# Traffic Planning Project Brief

Subject: ***Proposed Gas Station and Apartment  
1023 W. Main Street (IL 64) – St. Charles, Illinois***

# Memorandum

**Re:** 1023 W. Main Street (IL 64) – Proposed Gas Station and Apartment

Exhibit 3 - Site Plan

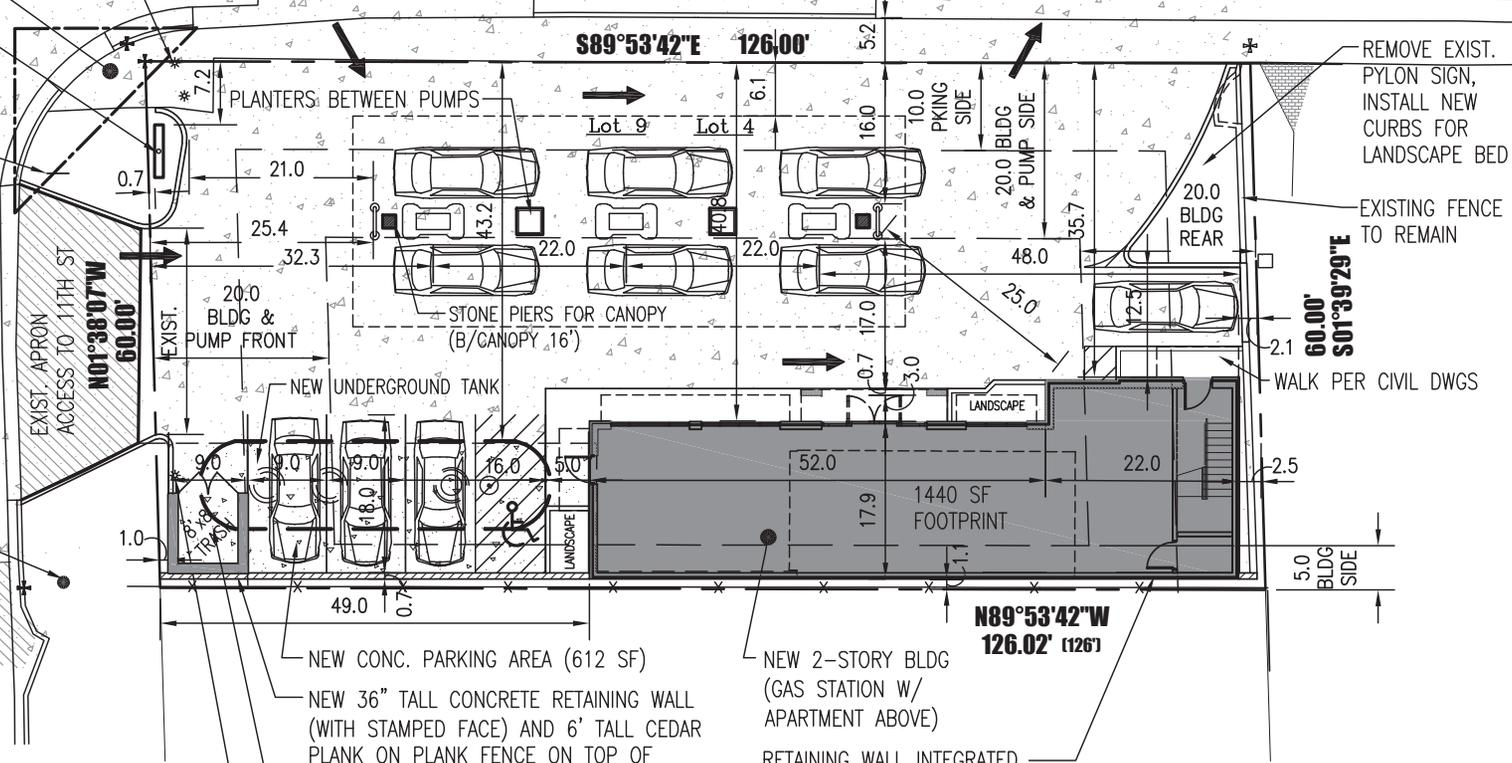
5. Include City Code parking requirements in Appendix and detail in study.
6. The proposed site plan shows less than 10’ of travel way between cars parked at the service pumps and the sidewalk on north side of the site/the convenience store on the south side of the property. There is concern if there is enough room for vehicles to maneuver the site properly. Provide passenger vehicle Auto-Turn exhibit for the proposed site plan.

7. There does not seem to be any curb or physical separation between the vehicle travel way and the sidewalk on the north side of the site which is a safety concern for pedestrians using the sidewalk.

11. Based on the circulation arrows on the current proposed site plan, does the driveway on 11<sup>th</sup> Street need to be full access if all vehicles are expected to travel in one-way direction through the site?

**Response:** Knoche Engineering will be providing the requested AutoTurn template.

**Response:** Knoche Engineering will be providing the requested AutoTurn template.

**AutoTurn was received.**

## TURNING EXHIBIT

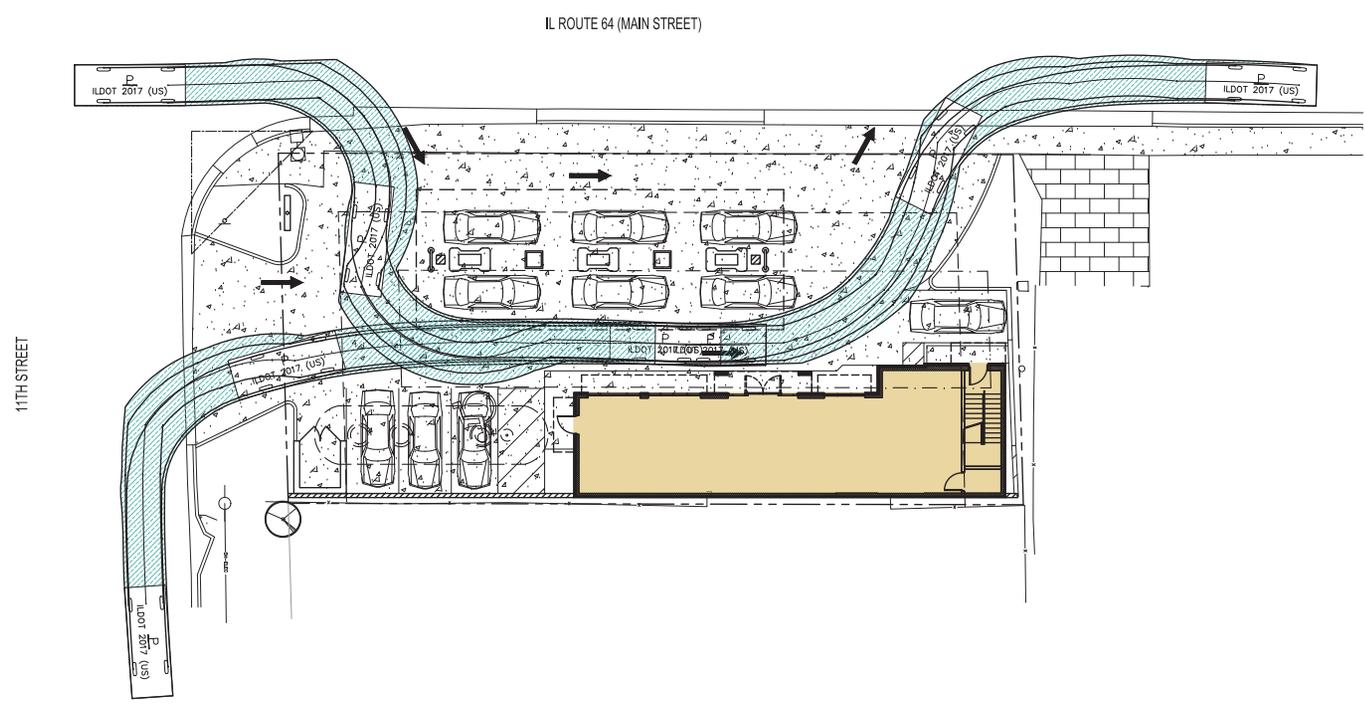
6. The proposed site plan shows less than 10' of travel way between cars parked at the service pumps and the sidewalk on north side of the site/the convenience store on the south side of the property. There is concern if there is enough room for vehicles to maneuver the site properly. Provide passenger vehicle Auto-Turn exhibit for the proposed site plan.
